RE: File No. 11239 – Rindge Commons Pre-K Interior Fit-Out - Addendum No. 2

Addendum No. 2

Rindge Commons Pre-K Interior Fit-Out

ADDENDUM # 2

Sheet Title
**LEVEL 1
POWER/LIGHTING
FLOOR PLANS**

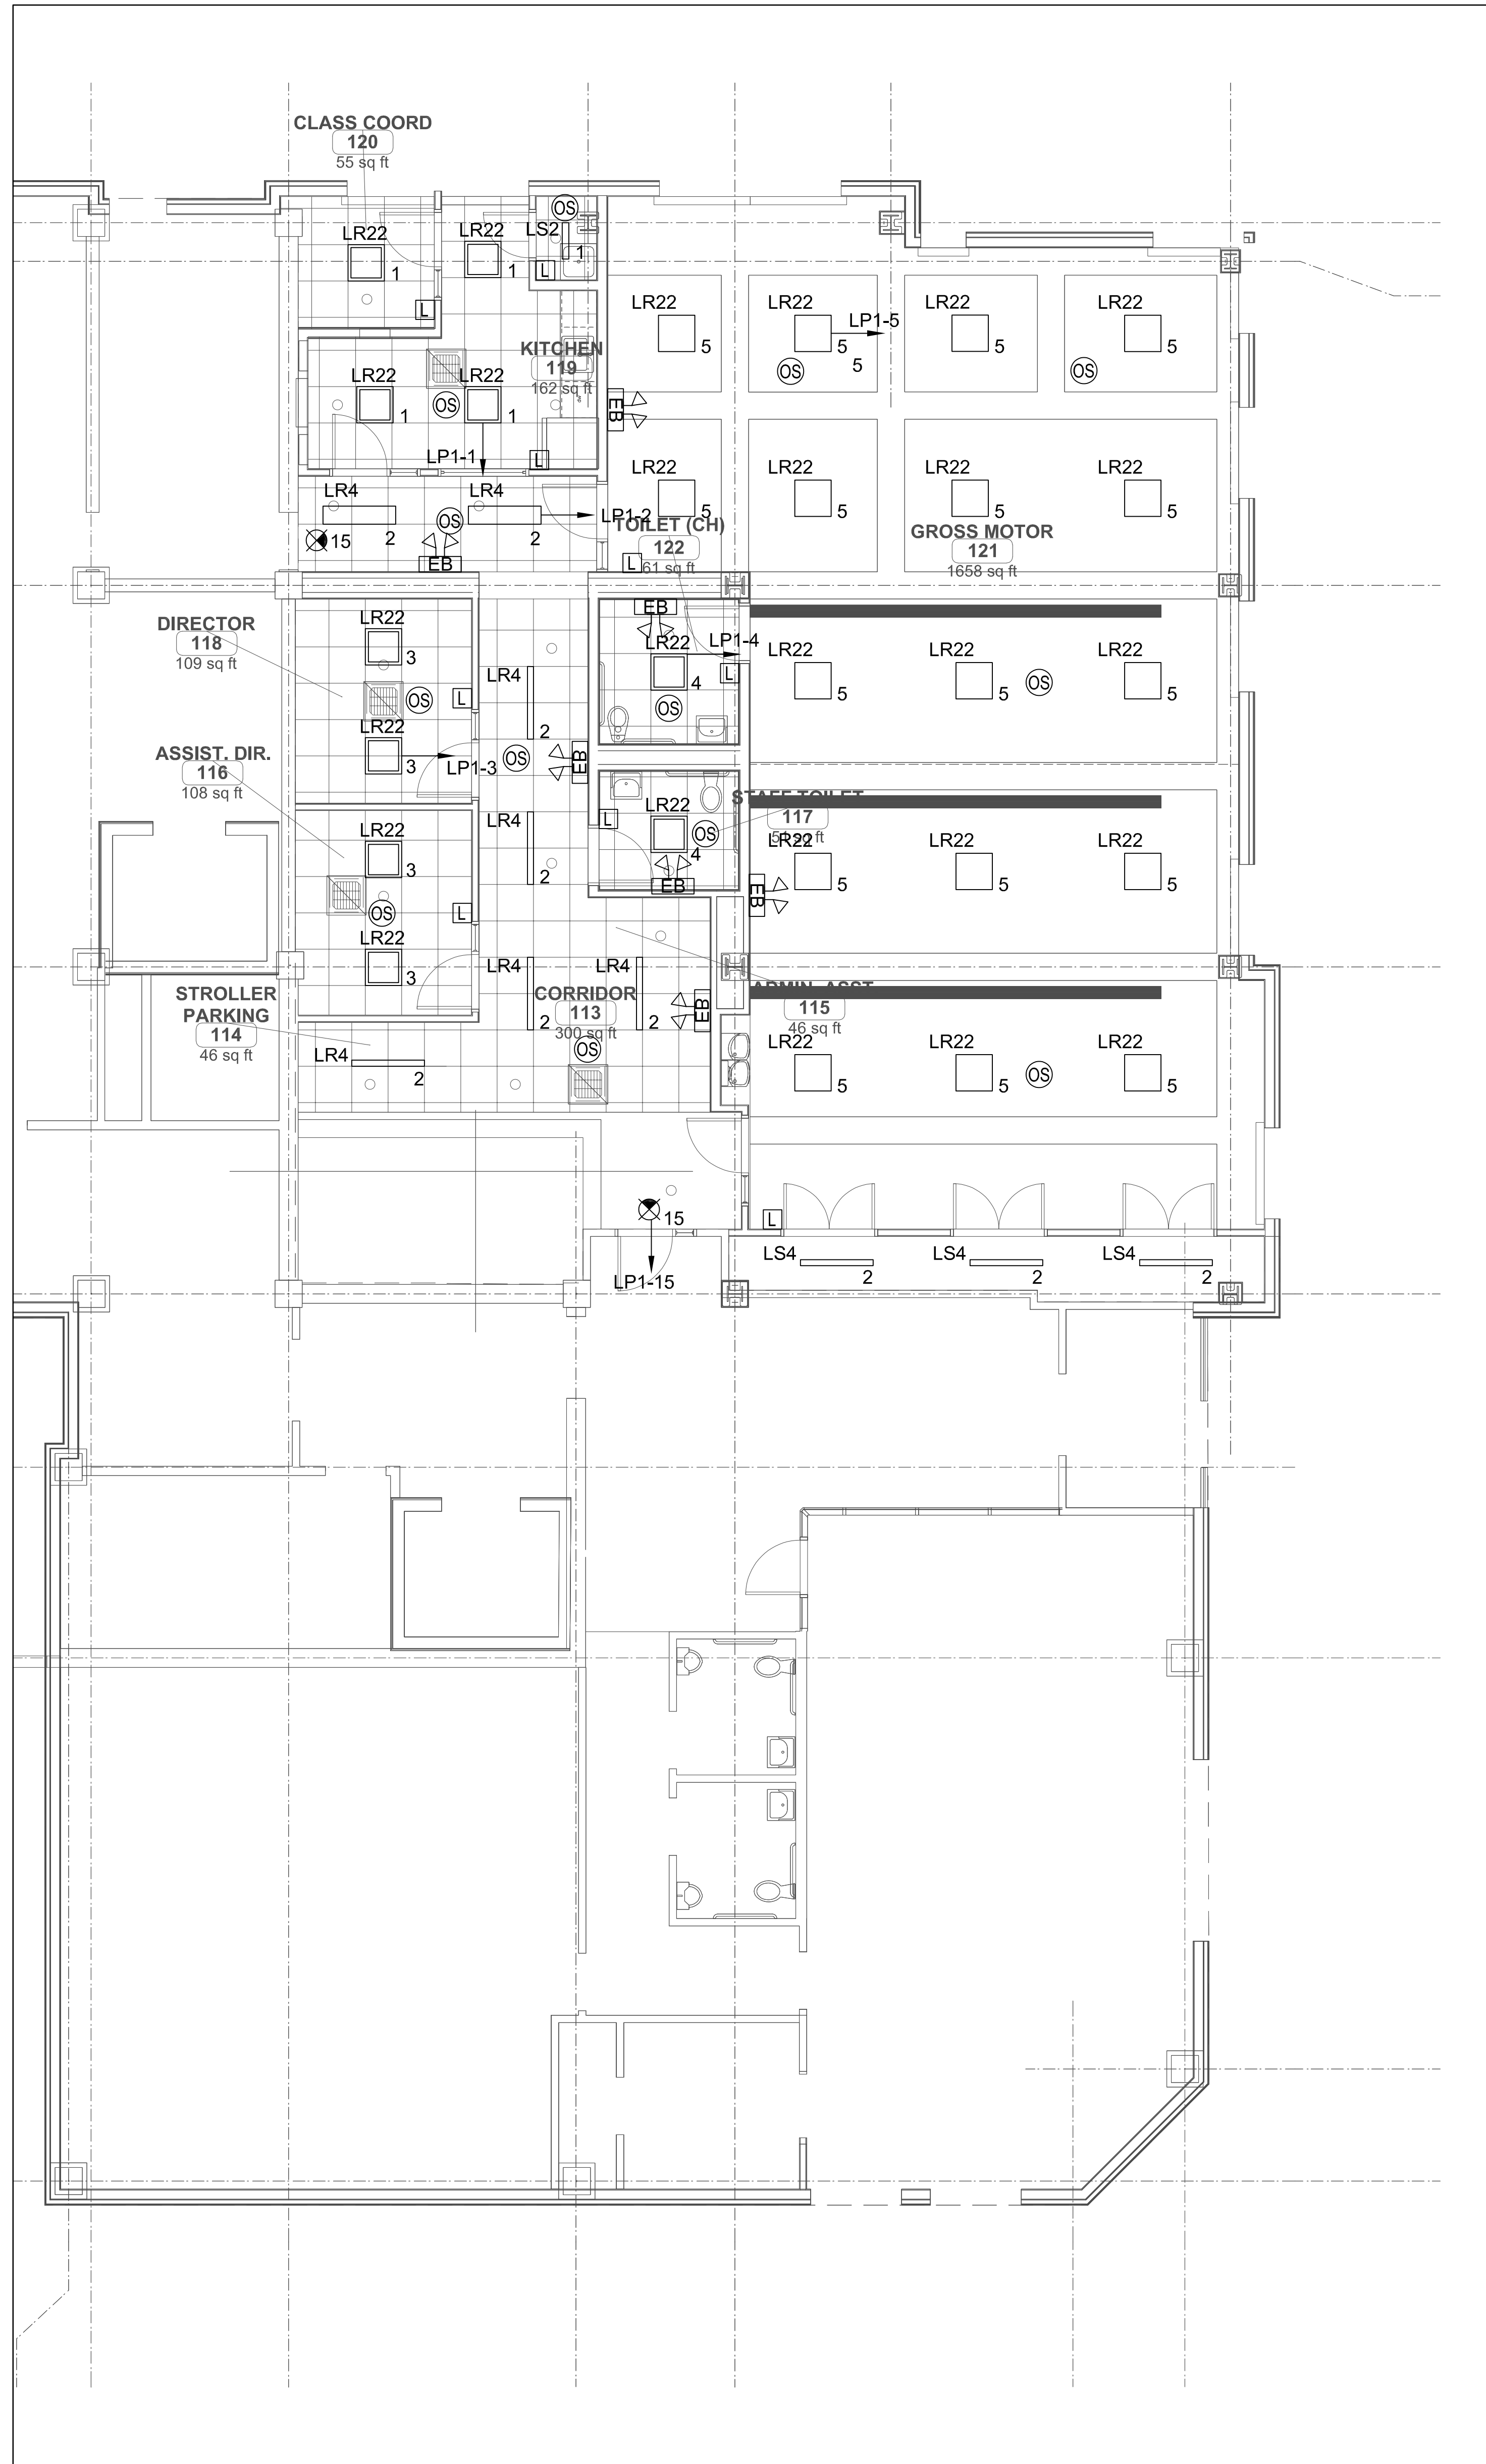
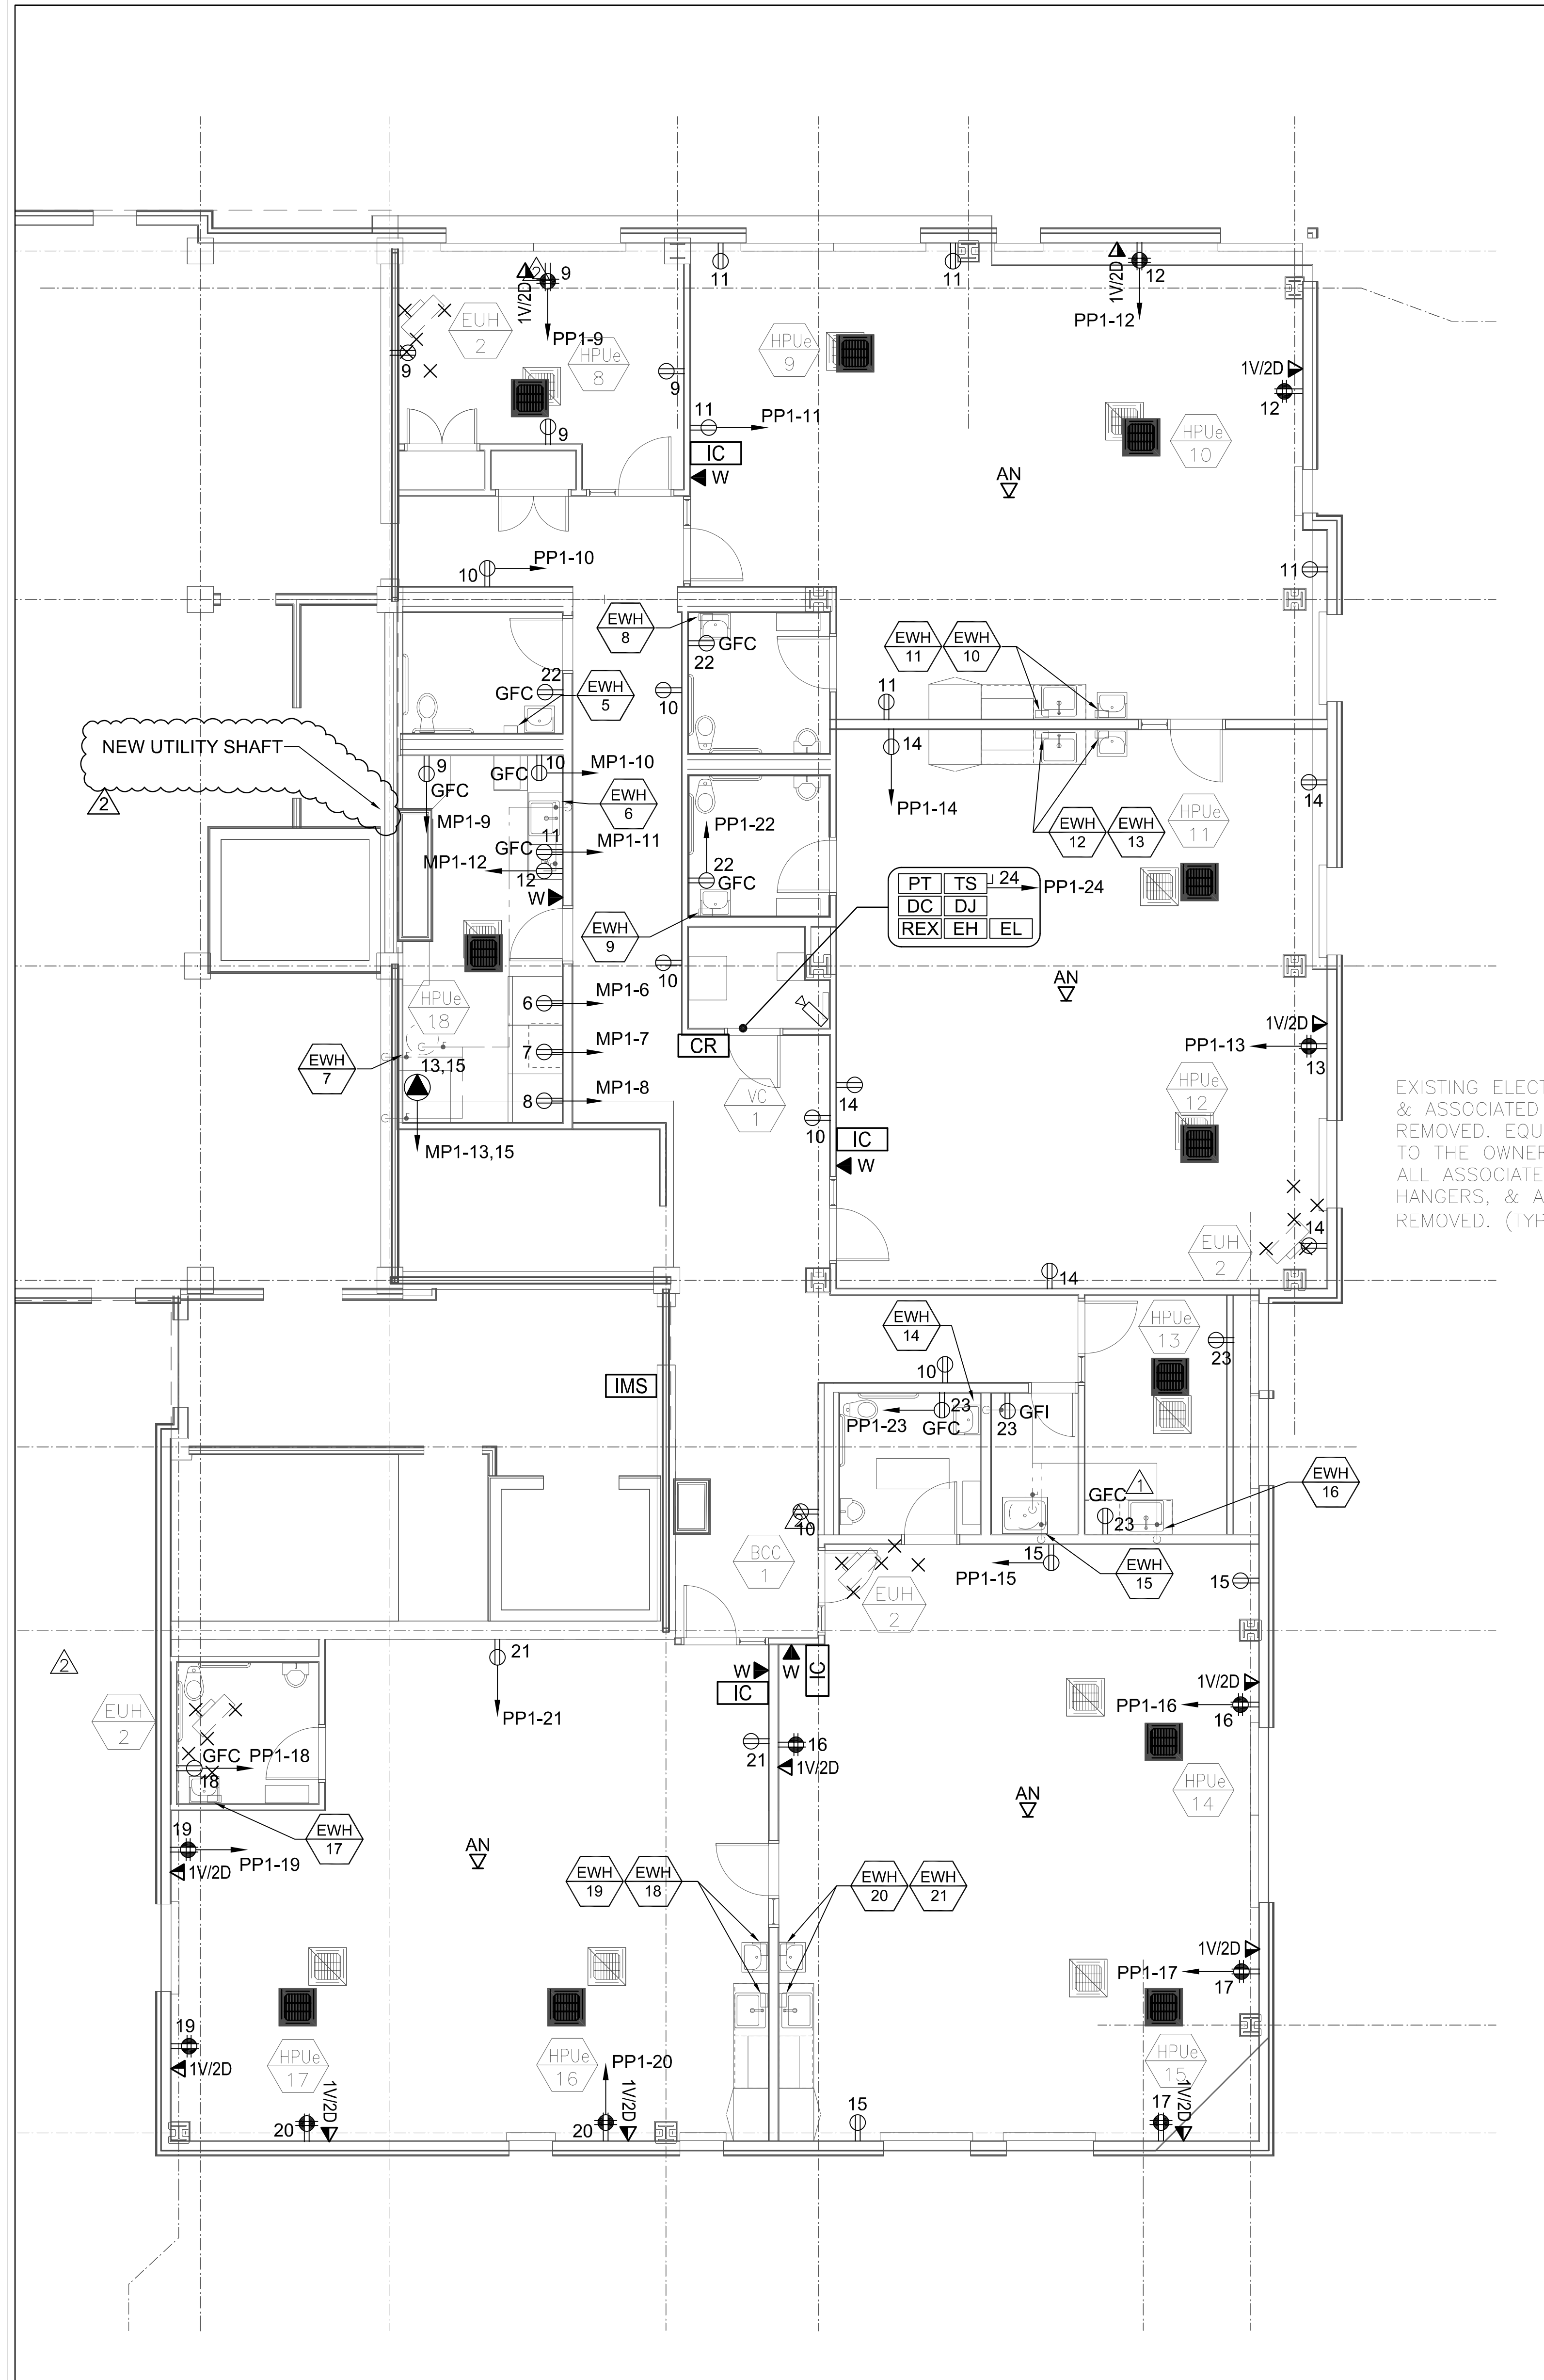
- **ITEM 2.4** Question: Drawing E0.3 - Electrical Riser: Please provide the location of new panels MDP, LP1, PP1, and MP1.
Response: Refer to Drawing E2.1.

- **ITEM 2.5** Question: Drawing E0.3 - Electrical Riser: Please provide the location of the new proposed shaft to serve the rooftop units.
Response: Refer to Drawing E2.1.

Response: Refer to specification revisions.
- **ITEM 2.9** Question: Drawing T1.2: low voltage riser, please provide the location of the main building demarc panel. Required for the fiber cabling
